INSPECTION REPORT
Sedimentation Structure
WW-9
Black Mesa Mine
Navajo County, Arizona
for
PEABODY COAL COMPANY

Dames & Moore
10139-011-22

CHANNEL PROFILE B-B'
WW-9

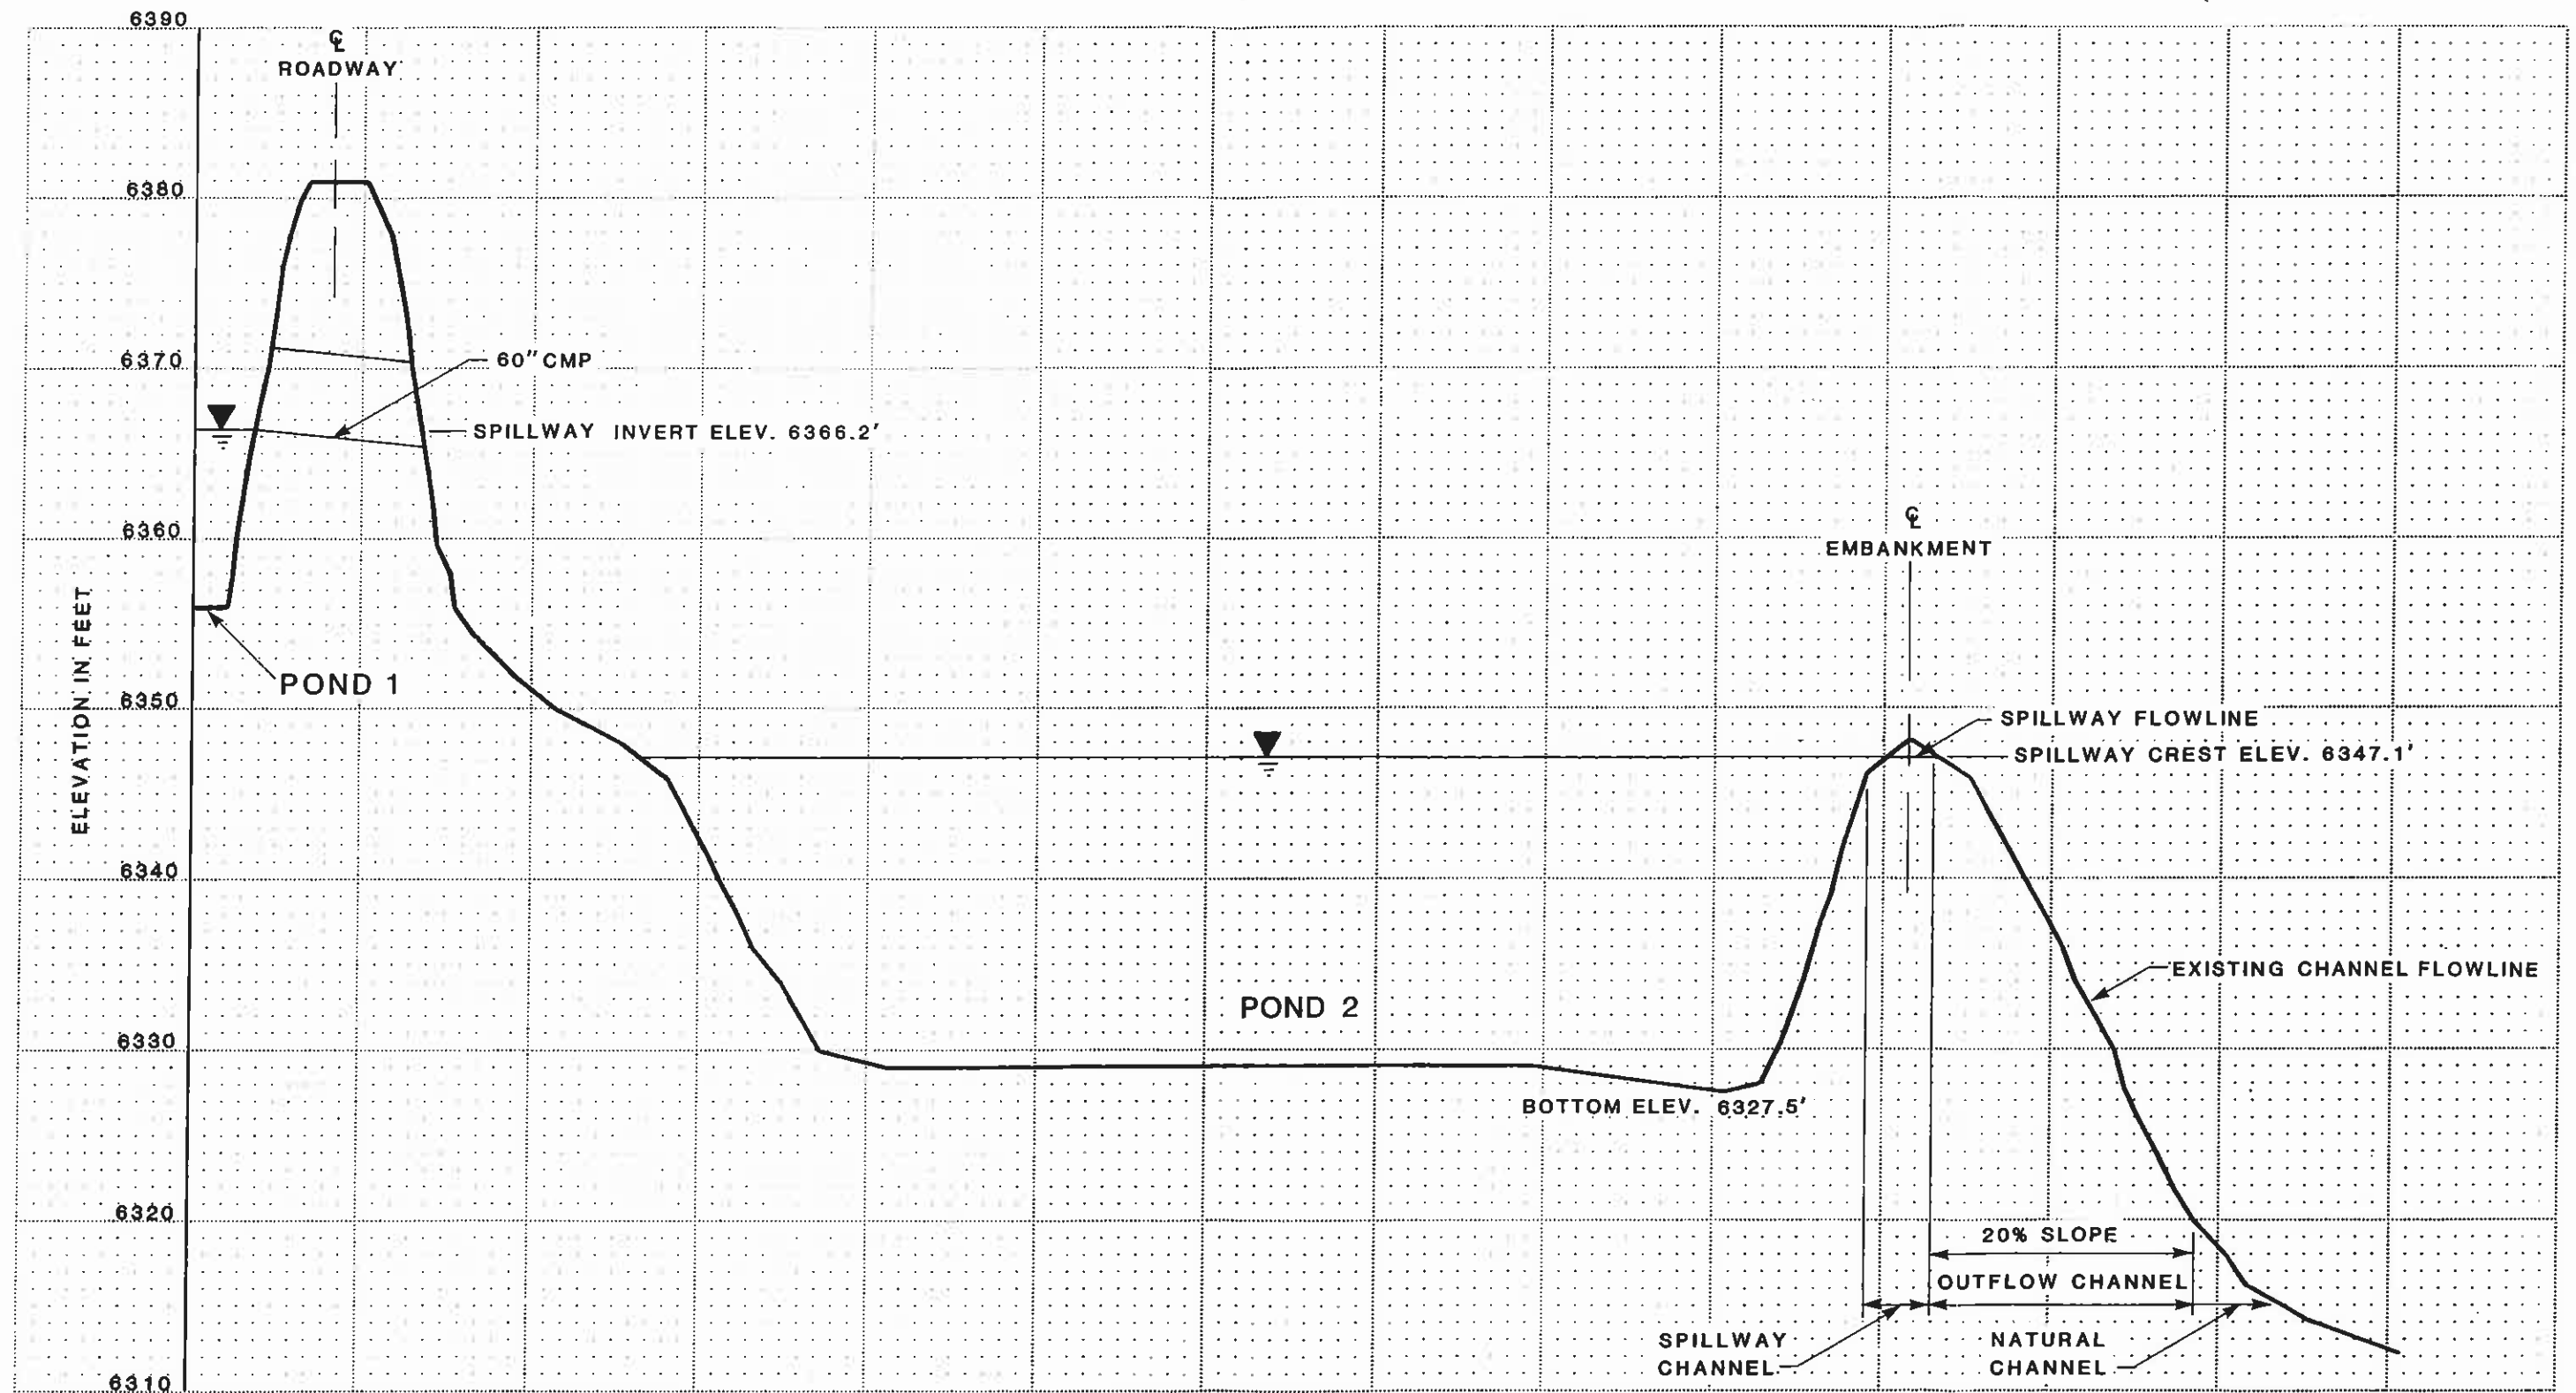
The storage capacity and spillway capacity of Structure WW-9 are adequate but the storage capacity exceeds 20 acre-feet. The bottom elevation of the existing spillway channel should be lowered to elevation 6347.10 feet while maintaining the bottom width of 65 feet. The spillway and outflow channel profiles are shown in Plates 4A and 4B. The spillway and outflow channel do not require any modifications.

Lowering the spillway elevation to 6347.10 feet decreases the storage capacity and increases the freeboard. The analysis of these conditions is summarized in the following table. A trashrack should be installed on the inlet of the CMP to prevent clogging of the spillway.
